City of Portland, Maine - Building or Use Permit Application 389 Congress Street, 04101, Tel: (207) 874-8703, FAX: 874-8716 Location of Construction: Owner: Phone: Permit No: 353 Cumberland Ave. 2nd Floor Bayside Coodwill Industries of Northers N. 823-3331 Owner Address: Lessee/Buyer's Name: Phone: BusinessName: SAA Permit Issued: Contractor Name: Address: Phone: 772-9822 Richaeluminum & Restoration 315 Park Ave. - 1 1999 COST OF WORK: PERMIT FEE: Proposed Use: Past Use: \$6,500 \$ 55.00 Office, Retail, Processing Same FIRE DEPT. Approved INSPECTION: ☐ Denied Use Group: Type: CBL:033-K-001 Zone: Signature: Signature: Zoning Approval: Proposed Project Description: PEDESTRIAN ACTIVITIES DISTRICT (P.A.D.) Construct six double window openings on Ind floor at Action: Approved Special Zone or Reviews: Portland Street corner. Approved with Conditions: ☐ Shoreland Denied □ Wetland ☐ Flood Zone ☐ Subdivision Signature: Date: □ Site Plan maj □minor □mm □ Permit Taken By: Date Applied For: 2-23-99 Zoning Appeal □ Variance This permit application does not preclude the Applicant(s) from meeting applicable State and Federal rules. ☐ Miscellaneous 2. Building permits do not include plumbing, sept

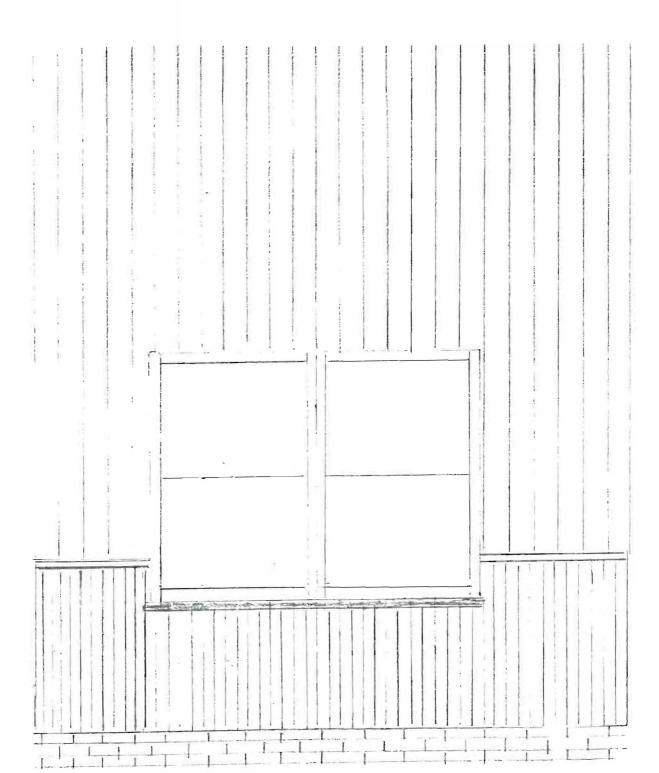
| ₹30. | Glass and glazing shall meet the requirements of Chapter 24 of the building code. |
|--------------|---|
| √ 31. | Care must be Taken IF This is a bearing wall - It Ihis is, |
| 1 | The case a design by a structural Engineer will be required |
| 32. | For heatlers over The windows. |
